APPLICATION FOR A RESIDENTIAL SITE IMPROVEMENT PERMIT/ CONSTRUCTION AUTHORIZATION FOR AN ON-SITE WASTEWATER SYSTEM, NEW WELL INSTALLATION, OR REPAIR OF EXISTING WELL

Re: Application for improvement permit for: 4 Bedroom House
Property Location: 4517 Watersway Ct, Charlotte, NC 28214
Health Department File Number: **10898B (App ID 11961)**

SOIL/SITE EVALUATION
for ON-SITE WASTEWATER SYSTEM

Sketch of Soil Evaluation Locations

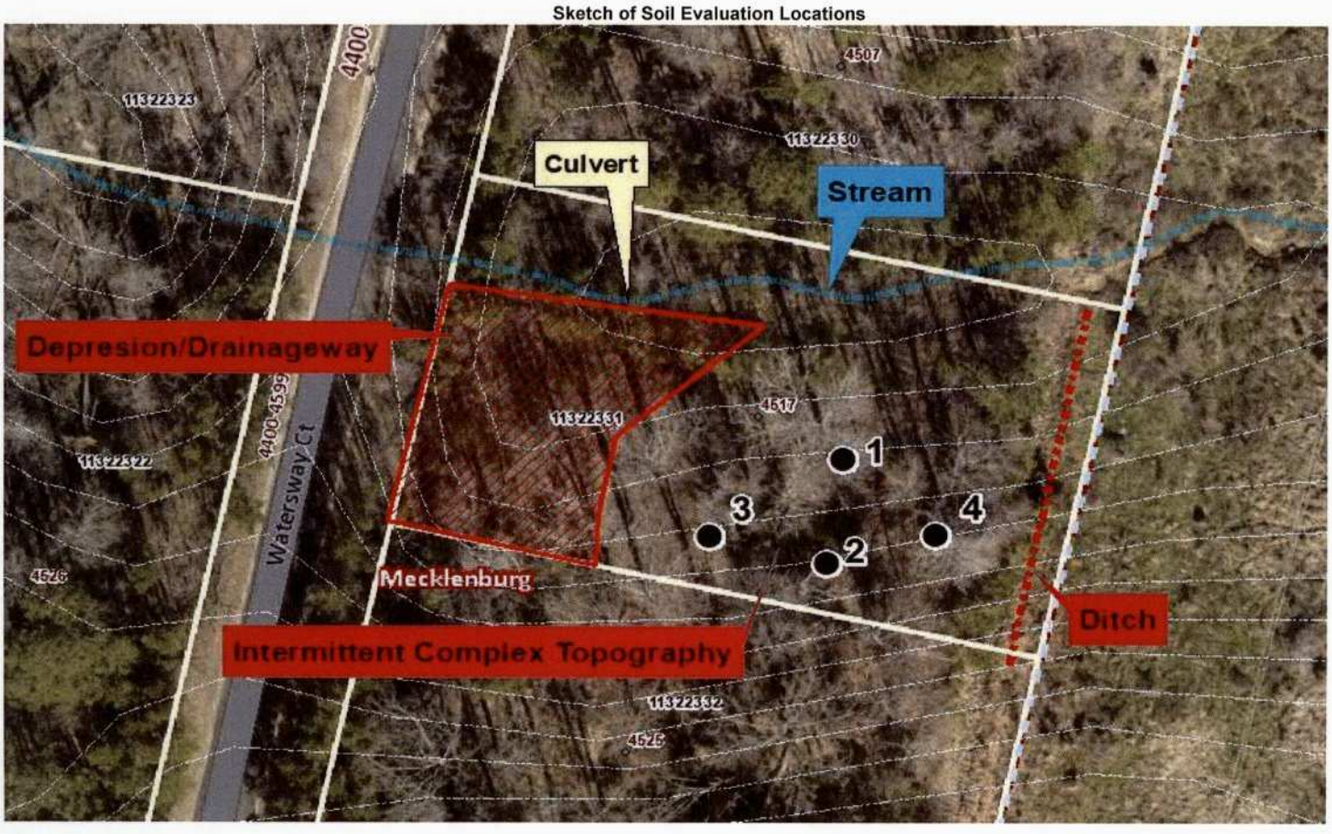
PROFILE #	.1940 Landscape Position/ Slope%	Horizon Depth (IN.)	SOIL MORPHOLOGY .1941 .1941 Structure/ Texture	.1941 Consistence Mineralogy	b PROFILE FACTORS .1942 Soil Wetness/ Color	.1943 Soil Depth (IN.)	.1956 Sapro Class	.1944 Restr Horiz	General Comments	**Profile Class & LTAR**	**Maximum Trench Bottom Depth for 3' Wide Conventional Trench**
Boring #1	FS 12%	0 - 5 5 - 30	gr CL sbk C	SS SP FR SEXP S P FI SEXP	10YR 8/1 at 24"	30	NA	NA		**US**	**NA**
Boring #2	FS 15%	0 - 4 4 - 42	gr CL sbk C	SS SP FR SEXP S P FI SEXP	10YR 7/1 at 39"	42	NA	NA	need curtain drain	**PS IV 0.225**	**22"**
Boring #3	FS 12%	0 - 3 3 - 30	gr CL sbk C	SS SP FR SEXP S P FI SEXP	10YR 8/1 at 28"	30	NA	NA	need curtain drain	**PS IV 0.2**	**12"** need cover
Boring #4	FS 12%	0 - 3 3 - 30	gr CL sbk C	SS SP FR SEXP S P FI SEXP	10YR 8/1 at 28"	30	NA	NA	need curtain drain	**PS IV 0.2**	**12"** need cover

COMMENTS: Curtain drain needed due to potential lateral flow from upslope.
